Change No. 8
 License No. DPR-19

We have reviewed your Proposed Change No. 8, dated January 19, 1971, requesting changes to Sections 1.1 and 2.1 and to Table 3.2.3 of the Technical Specifications of Provisional Operating License No. DPR-19. The proposed changes would extend the core thermal safety limit to 120% of design recirculation flow and change the slope of the APRM flow biased scram and rod block curves. These changes will make the corresponding sections of the Technical Specifications for Dresden Nuclear Power Station Units 2 and 3 identical.

UNITED STATES
ATOMIC ENERGY COMMISSION
WASHINGTON, D.C. 20545

Figure 1.1.1. Core Thermal Safety Limit

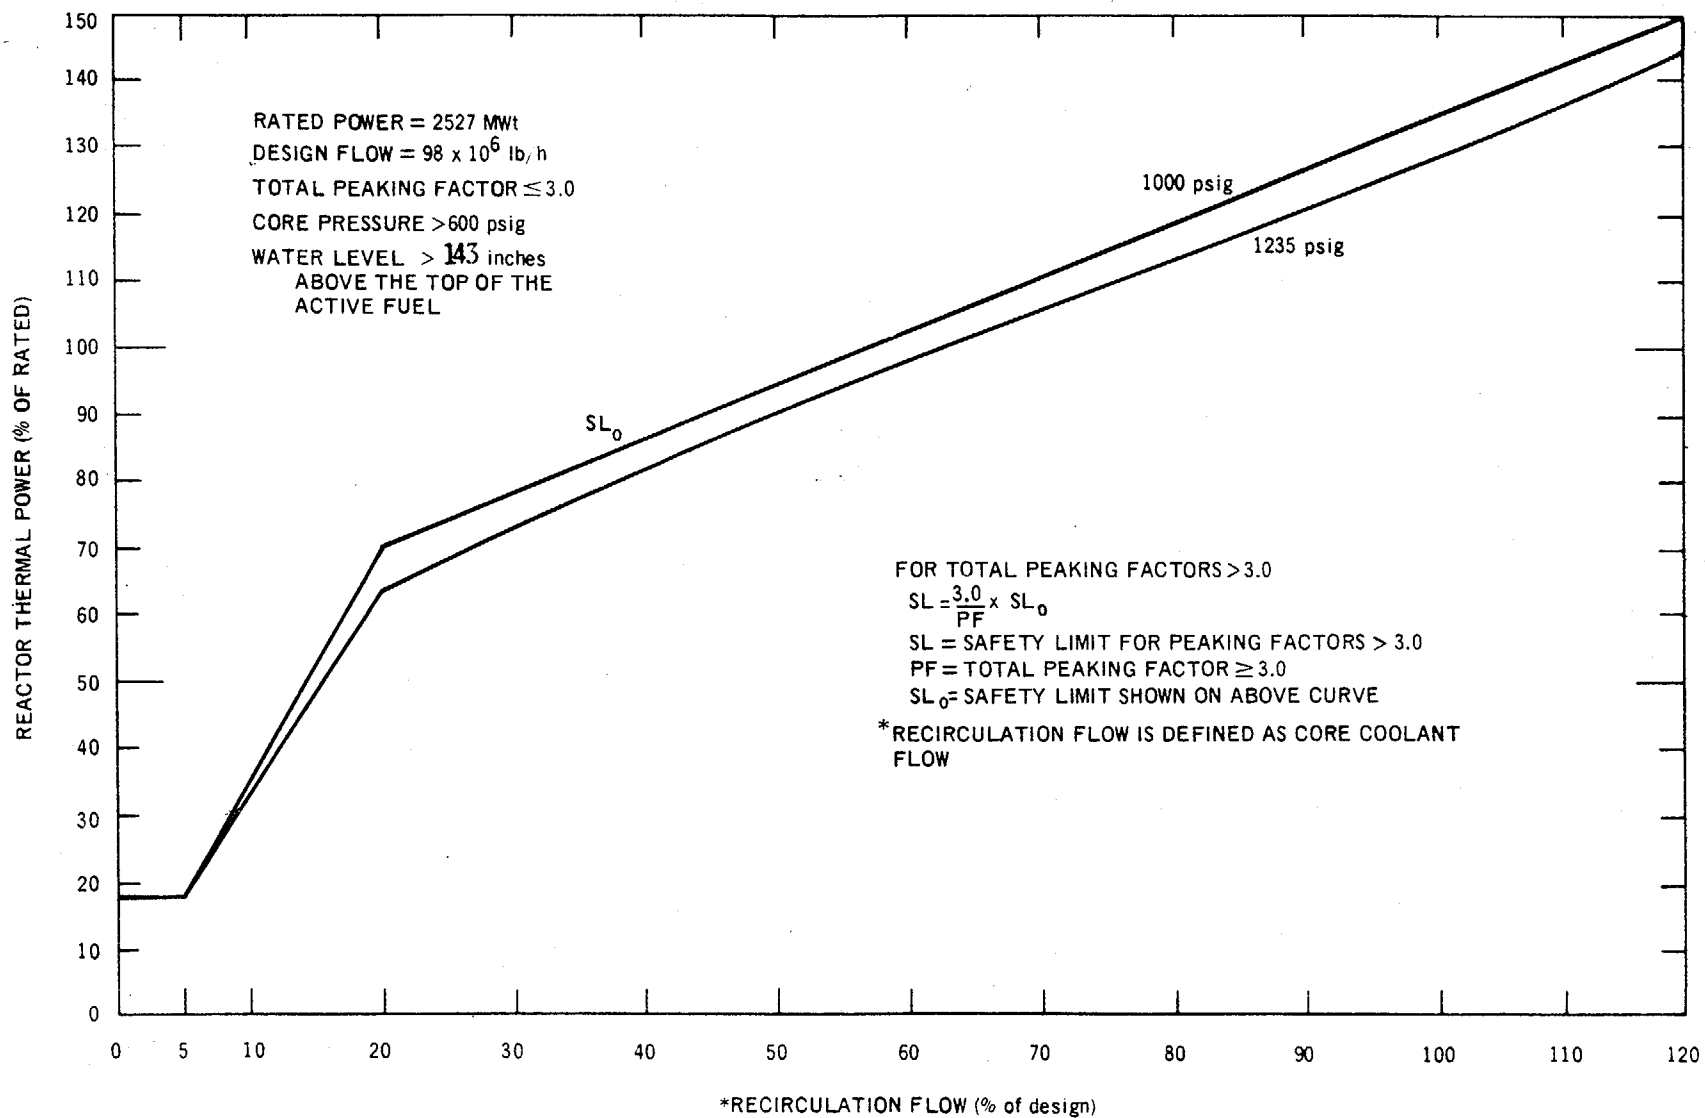
The safety limit curves shown in Figure 1.1.1 represent the locus of operation conditions for which the maximum powered rod has a minimum critical heat flux ratio (MCHFR) equal to 1.0. The MCHFR value was determined using the design basis critical heat flux correlation given in APED 5286⁽¹⁾. The operating range with MCHFR > 1.0 is below and to the right of these curves. The evaluation is based on the operating map as given in Figure 3.2.3 of the SAR.

Curves are presented for two different pressures in Figure 1.1.1. The upper curve is based on a nominal operating pressure of 1000 psig. The lower curve

The power shape assumed in the calculation of these curves was based on design limits and results in a total peaking factor of 3.0. For any peaking of smaller magnitude, the curves are conservative. The actual power distribution in the core is established by specified control rod sequences and is monitored continuously by the in-core Local Power Range Monitor (LPRM) System. However, to maintain applicability of the safety limit curve, the safety limit will be lowered according to the equation given on Figure 1.1.1 in the rare event of power operation with a total peaking factor in excess of 3.0.

Figure 2.1.1.1. APRM Flow Reference Scram and APRM Rod Block Settings

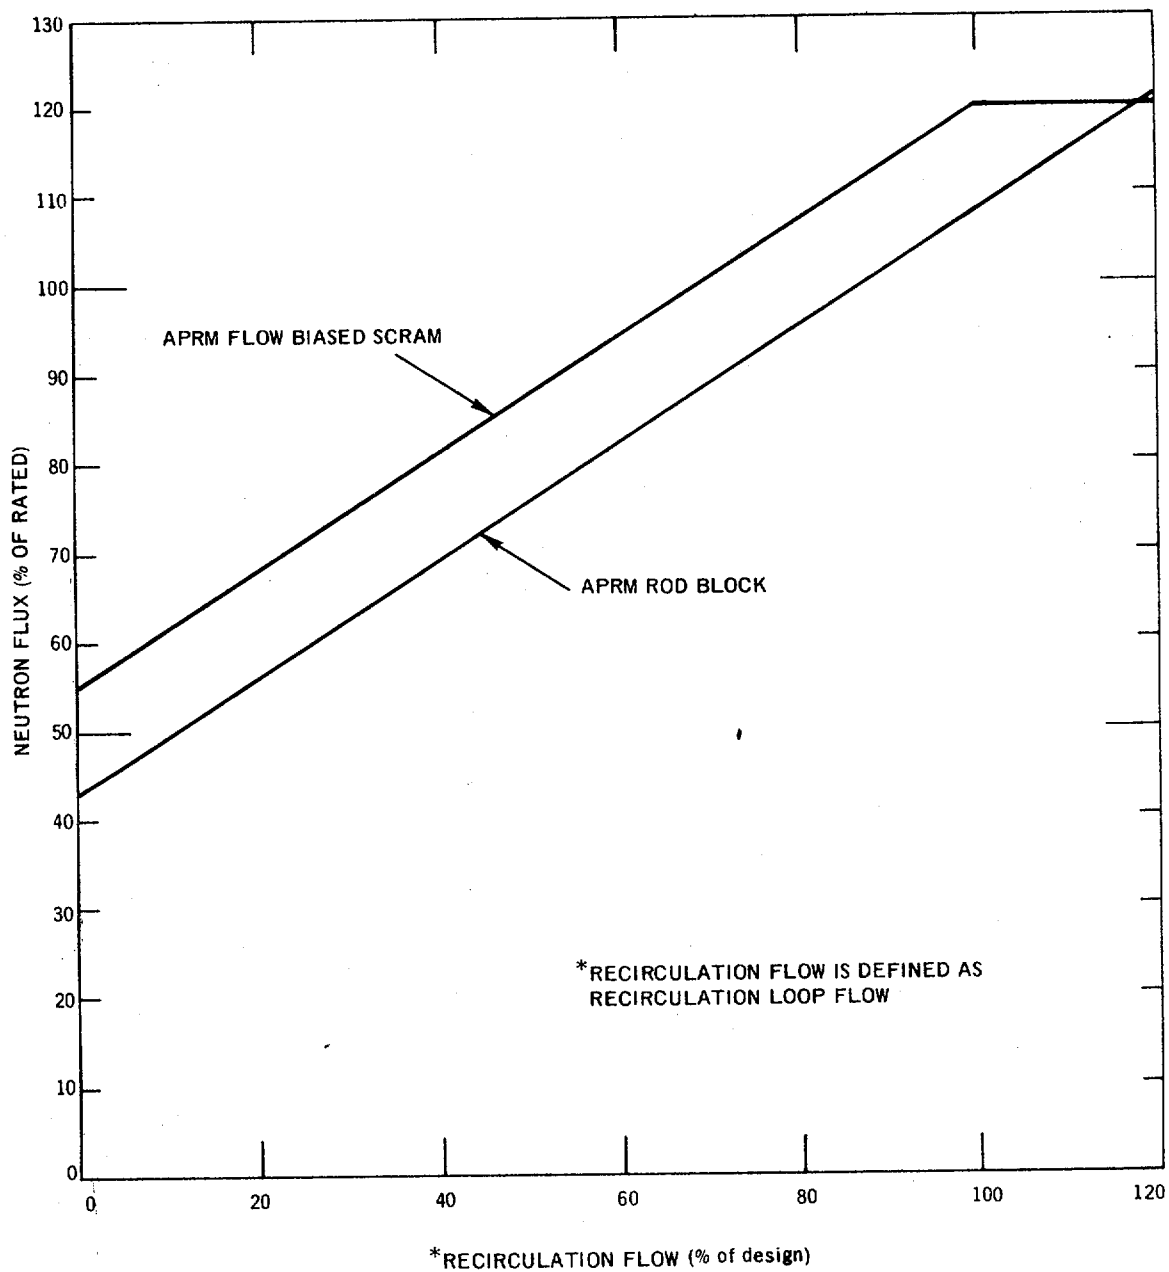
constant of the fuel. Therefore, during transients with an APRM scram setting as shown in Figure 2.1.1, the thermal power of the fuel will be less than that indicated by the neutron flux at the scram setting. Analysis reported in the SAR demonstrates that, even with a fixed 120% scram trip setting, none of the postulated transients result in violation of the fuel safety limit and there is a substantial margin from fuel damage. Therefore, use of a flow-biased scram provides even additional margin. See page 15 for further comparison.

An increase in the APRM scram setting to greater than that shown in Figure 2.1.1 would decrease the margin present before the thermal hydraulic safety limit is reached. The APRM scram setting was determined by an analysis of margins required to provide a reasonable range for maneuvering during operation. A reduction in this operating margin would increase the frequency of spurious scrams which have an adverse affect on reactor safety because of unnecessary thermal stress which it causes. Thus, the APRM setting was selected because it provides adequate margin from the thermal hydraulic safety limit yet allows operating margin which minimizes unnecessary scrams.
